Date: October 10, 2016

From: George Wooten

## Re: DNS 16-061: METHOW FOREST HABITAT RESTORATION

Figure 1. Steep channels that should receive 300-foot setbacks from the sediment delivery zone.

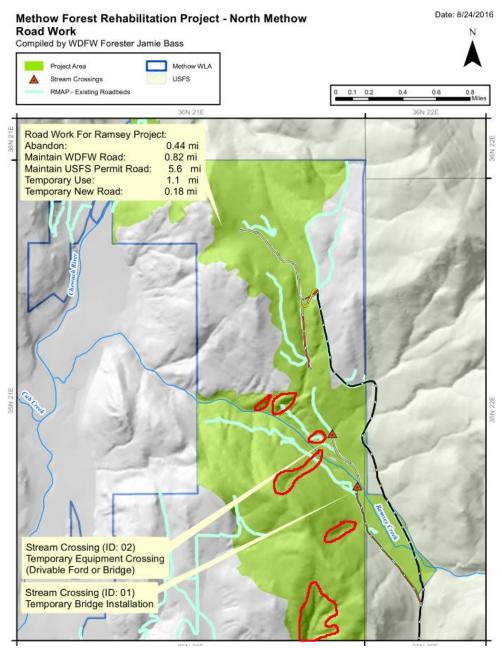
Based on a consensus across the region, ground-based logging should be limited to slopes > 35% (e.g., refer to Mission Project objectives on USFS lands). On slopes > 35%, or in areas with unstable slopes, ground-based equipment should be restricted further than the sediment delivery zone, or 300 feet from perennial channels. We identified areas where 300-foot buffers may be appropriate (Figure 1), on steep slopes with steep channels on the ridge south of Ramsey Creek. We appreciate that you

have tried to protect this area from erosion by restricting most treatments here to controlled fire and non-commercial thinning, but several areas appeared to have been omitted from the Checklist or maps.
